STOREY PARK MULTI-FAMILY DEVELOPMENT

SUMMARY

Owner Linus LLC Applicant Rick Ortiz, Poulos & Bennett Project Planner Michele Gibbs Updated: October 12, 2022	Property Location: 11351 Biography Way (North of Biography Way, East of Moss Preserve Pkwy, South of Dowden Rd, West of Story Time Dr.) (±13.7 acres, District 1) Applicant's Request: The applicant is requesting Master Plan approval for a 325 dwelling unit multi-family development in four and five story buildings within the Wewahootee (Storey Park) Planned Development.	Staff's Recommendation: Approval of the request, subject to the conditions in this report. Public Comment Courtesy notices were mailed to property owners within 300 ft. of the subject property during the week of October 3, 2022. As of the published date of this report, staff has received several emails and phone calls from the public concerning this request.
--	--	--

Staff recommends approval of MPL2022-10073 subject to the conditions below:

Elevations (4-Story clubhouse/Amenity area)

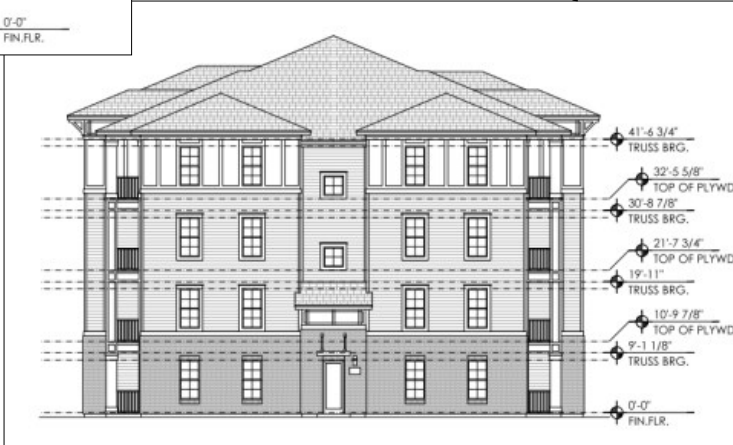
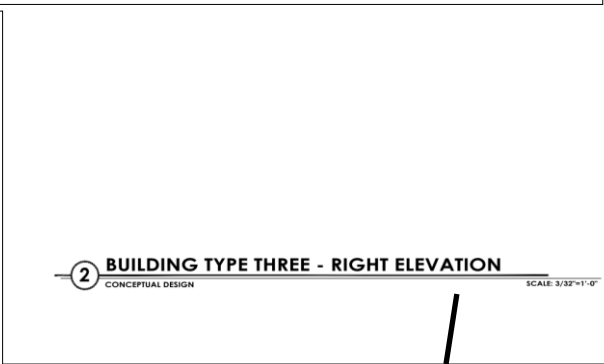
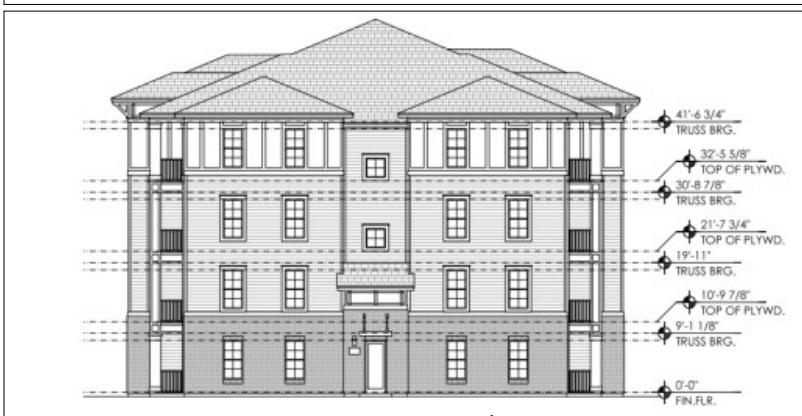
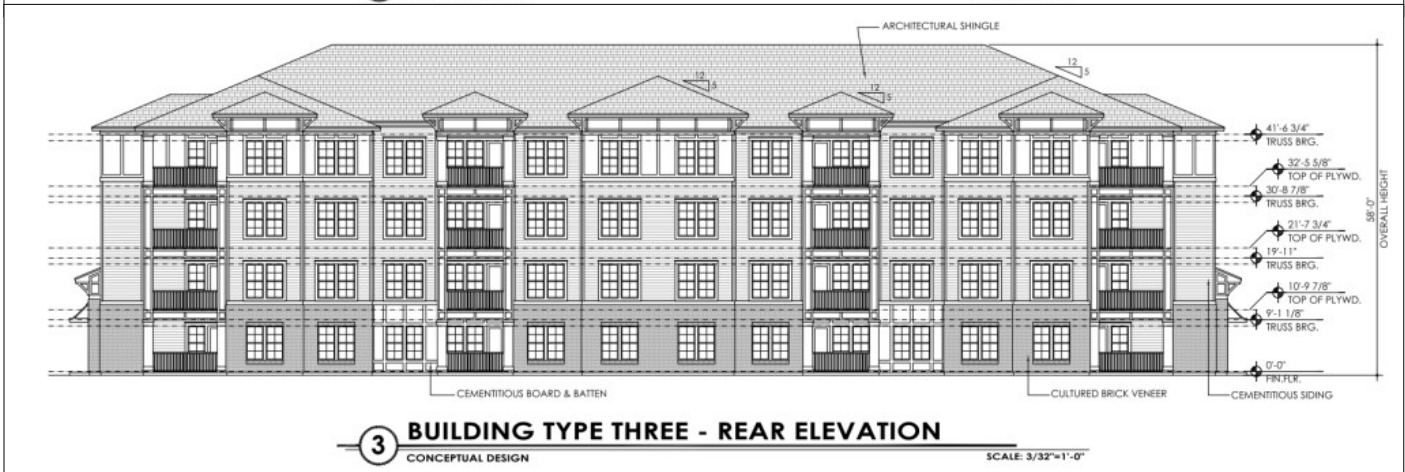
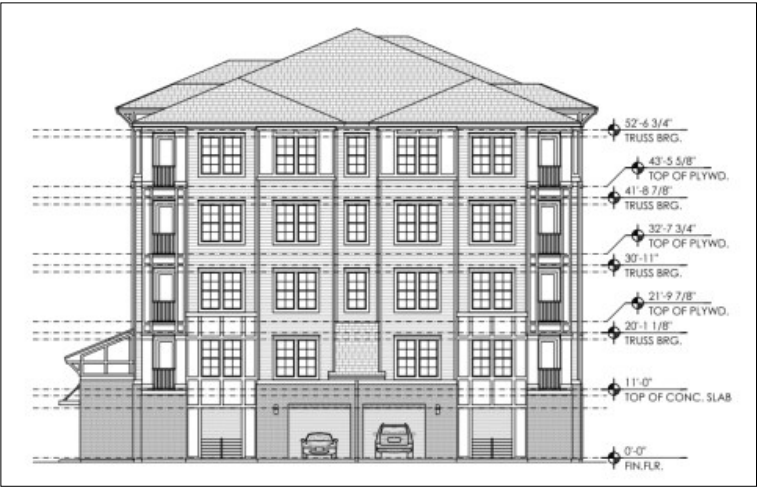
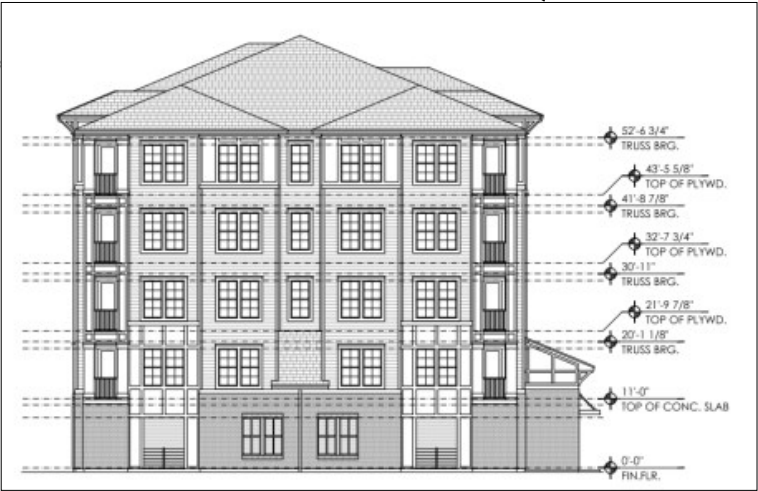
6. Elevations must match what's proposed in the master plan submittal. Any substantial changes to the elevations may have to go back through the process for approval.
